DOCUMENT CHANGE REQUEST

DCR number 249

Title: Connectors Electrical Rectangular Non-Removable Solder Bucket PCB and Wire-Wrap Contacts

Number: 3401/001

Plug Contact Cavity Arrangements — High Density

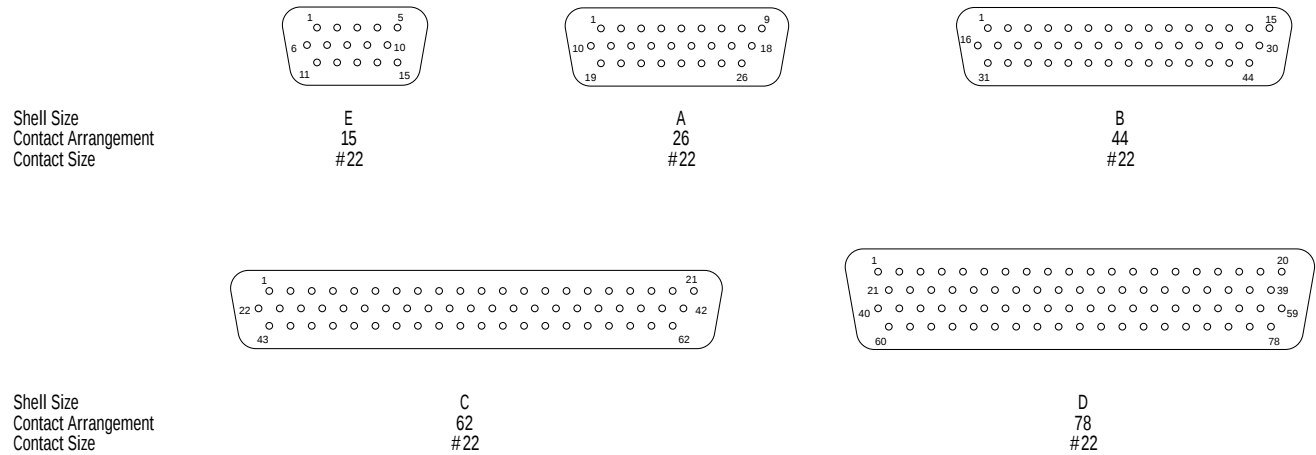
In figure 2(b) is presented the contact layout of D-connector 78 Contact, Gauge 22. The contact layout/numbering is incorrect. In picture there are presented incorrectly 79 contacts.

Correct contact layout presented in attachment.
